Agenda
City of Sacramento
Design Commission

Subject: **625 H Street (DR10-033)** Located at the northwest corner of 7th and H Streets, a request to develop an eight story mid-rise 150 unit residential tower including 2,800+/- s.f. ground floor retail and 6,000 s.f. health clinic on 0.55+/- acres in the Central Business District Special Planning District (C-3-SPD) zone.

SUBJECT: Response to Design Review Comment Letter dated 4/29/10, the letter summarizes the 4/21 Design Commission "Review and Comment Hearing"

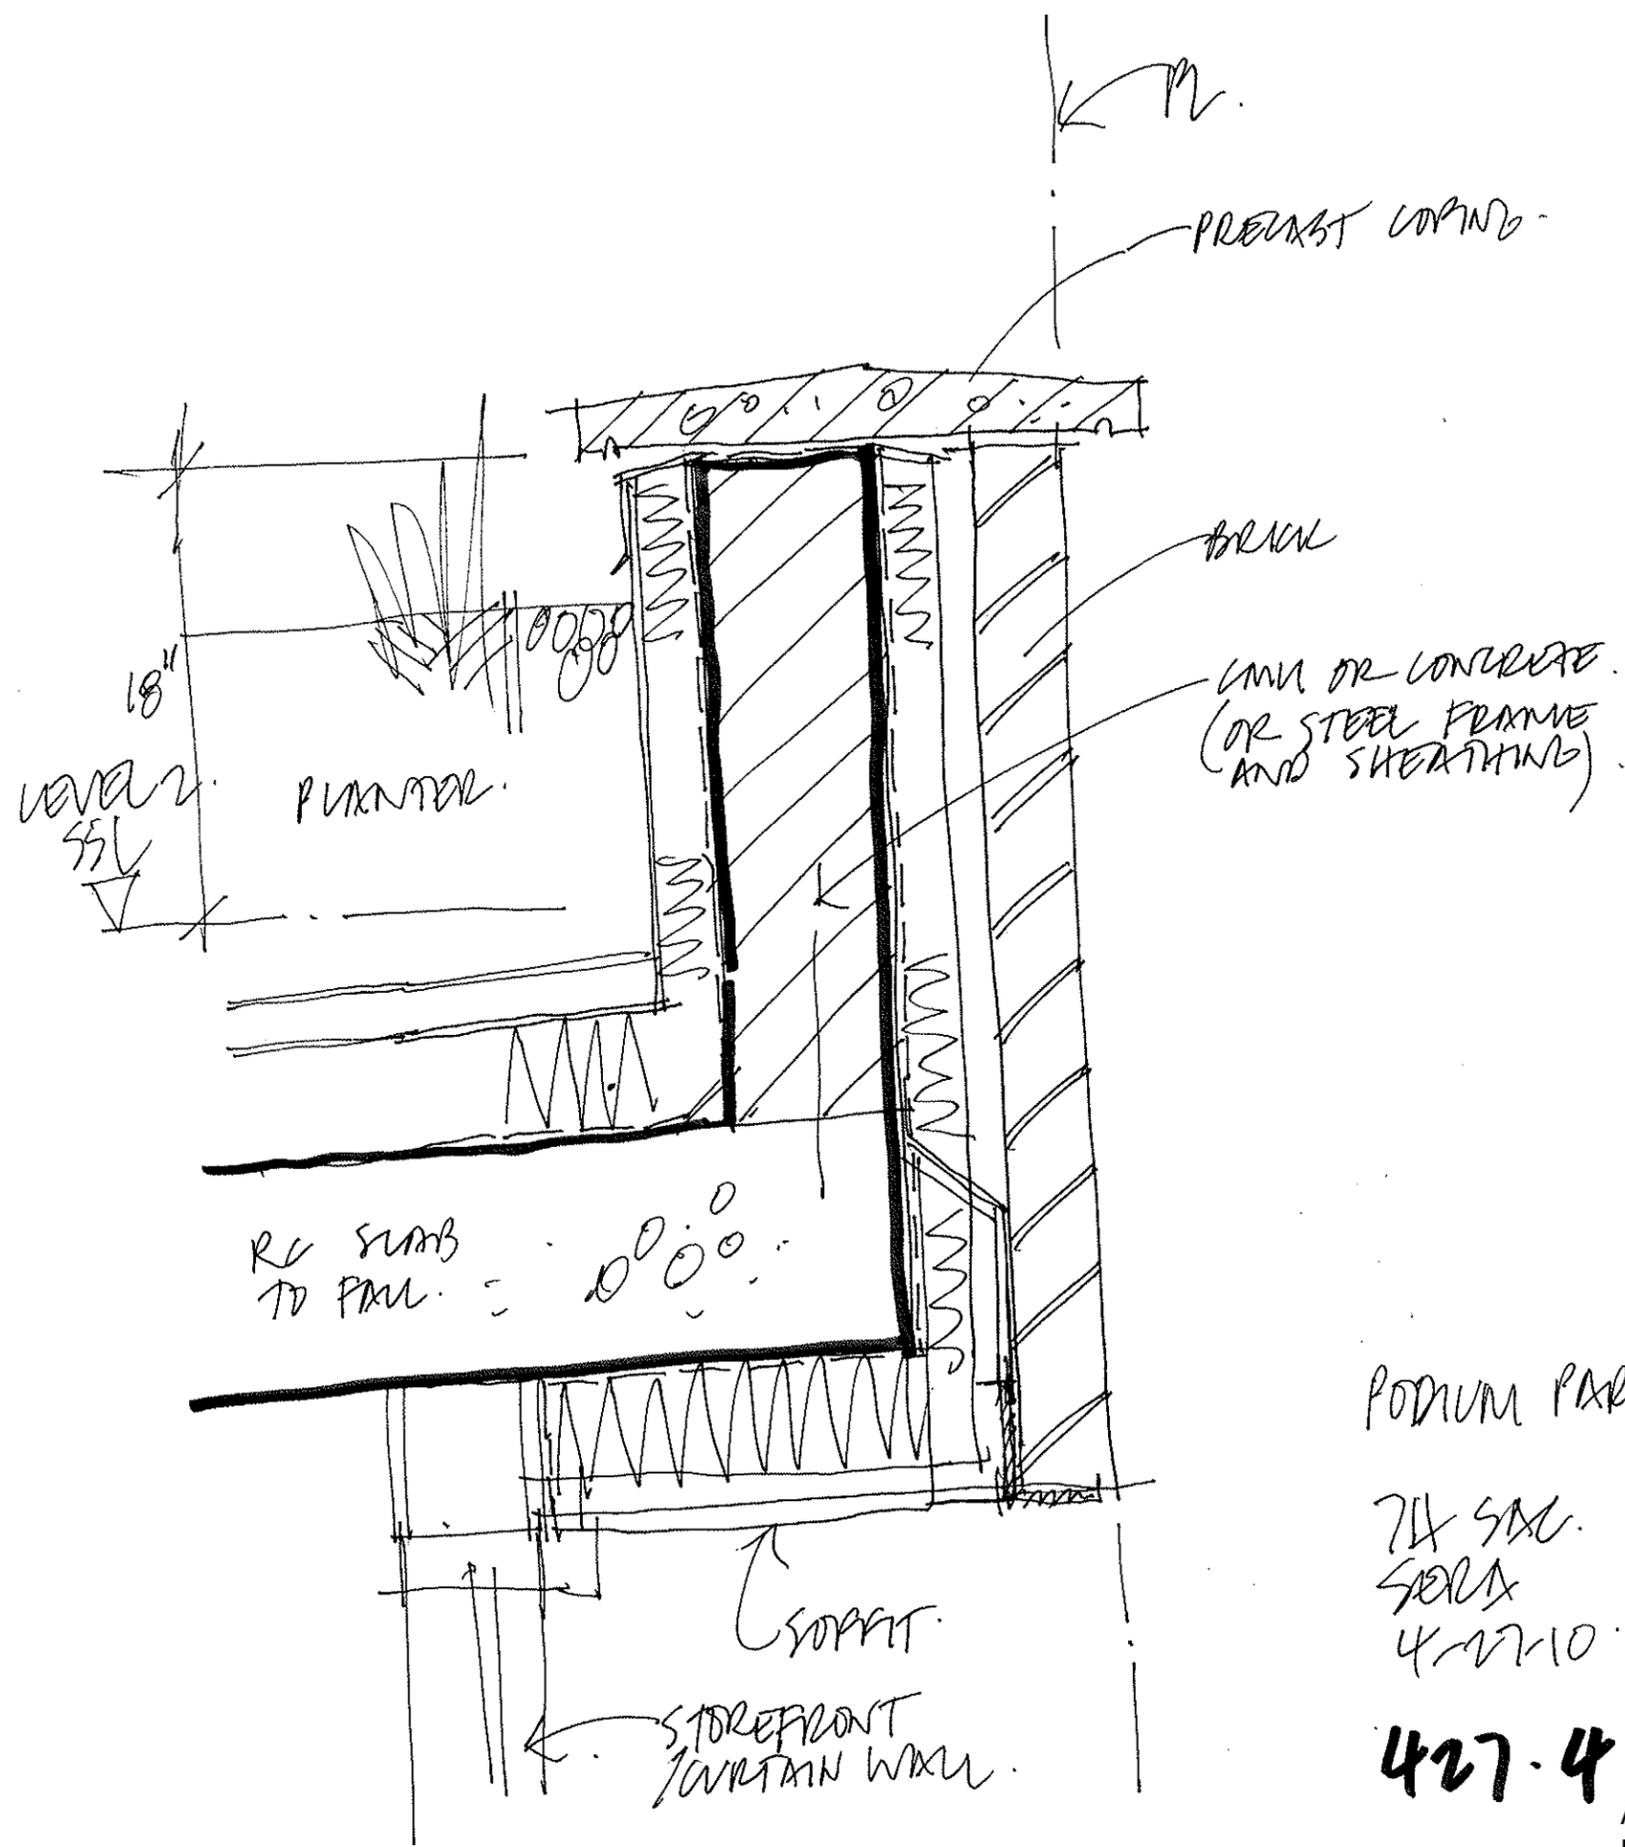
5. The West elevation needs to be improved and more articulated because of the east bound traffic on H street.
 - a. This elevation consumed more of the design team's effort – with dozens of sketches and hours of discussion. The challenge is to develop an interesting change in the building, while not compromising the disciplined brick pattern. While trying to stay within budget, the team considered adding massive metal expressions in the skin, tower elements, pop-outs of multiple shapes, exotic sun-shading devises, etc. We

finally settled on the revised design that is a little “zoomy” while still using the “language” that the rest of the building skin.

- b. A wedge-shaped pop-out punctuates the top two floors of the building creating the sense of that the “horizontal weave” brick pattern is peeling back from the building. This creates a triangular shadow on the west elevation, shades some of the windows below, and sets the building into a horizontal motion, giving it drama.

- c. The metal panel element at the inside corner has also be raised up above the parapet with extended walls back into the roof to break the cornice and make it more interesting. The metal extends back into the room to give the illusion that it is a metal tower emerging from the room. This will be most visible in a revised sketch perspective of the west wall –to be presented in the 5/19 hearing.

- e. In addition, we noticed that the tree canopy was not rendered high enough on the west elevation, showing the trees (on top of a 3’-6” tall planter) to be only 8 or 9 feet tall. Realistically, we should expect a canopy at about 18’ above the terrace so this has been changed in the elevation.

- f. Overall we feel that this is a much stronger west elevation and hope that the commission agrees. **See revised west elevation page 14 of drawing set.**

7TH & H
Roof Level without PV
2010.05.10
scale: 1" = 20'-0"

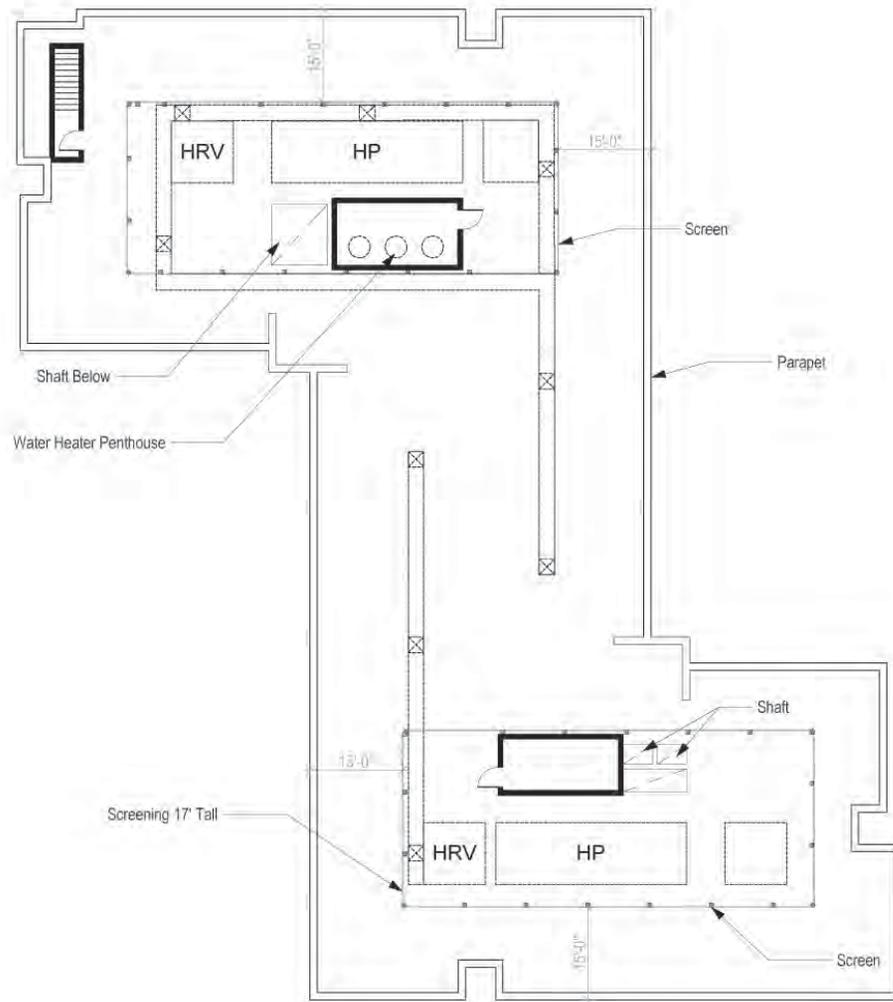
7. The prevalent views from I-5, Railyards, and general city skyline will require additional refinement/treatments of the building top and mechanical penthouses. Please provide revised plans incorporating the mechanical penthouse and the building top (cornice) as an integral part of the building regardless of the PV array as the proposed elements need further refinement and articulation.

10. Perforated metal mechanical screening and a renewed possibility of the photovoltaic panel system are the solutions provided to finish the building top. These modifications still seem short of what the Design Commission requested. Staff recommends that solid metal paneling provided on the lower floors of the building be utilized in place of the perforated metal screening, due to the varying sizes and locations of the

- ii. **WITHOUT SOLAR ALTERNATIVE:** If the solar array is not constructed, the team is committed to screening the mechanical equipment per the attached screening plan sketch – **see DR2-4**. The screening would also be constructed of the metallic screening described above and illustrated similar images attached. The team is still developing sketches for this screening concepts, to be submitted at the 5/19 hearing.

PARAPET
SECTION.
7H SAE
SOCA.
4-1#10.

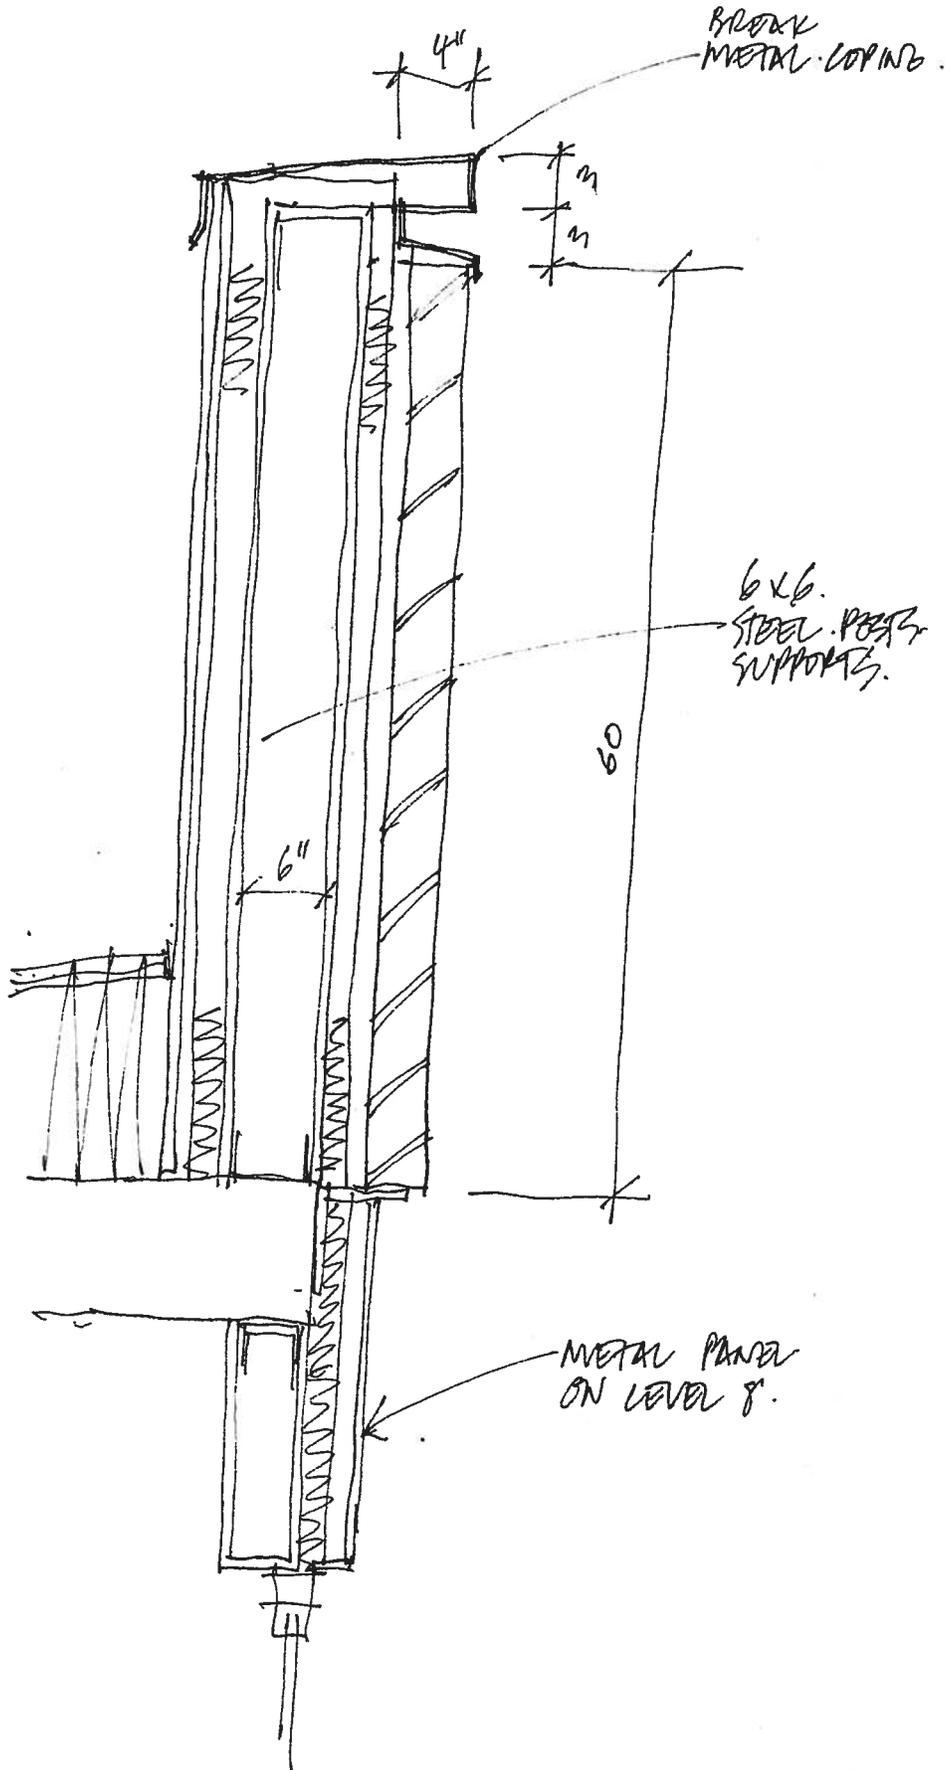
7. As per previous staff comments, the revised elevations have not reflected the request to provide a shadow line above the window similar to that of the aluminum louvered sunshades provided at the south elevation. The previous response detail proposed a course of inset dark brick to simulate the shadow line created by the awning is still supported by Staff.

- b. The cornice (“building top”): With or without the solar array, the cornice has been altered to include a 2’ tall metal coping with a deep reveal to create a shadow line. A detail sketch of the parapet has been added to the submittal. **See exhibit DR2-5**.
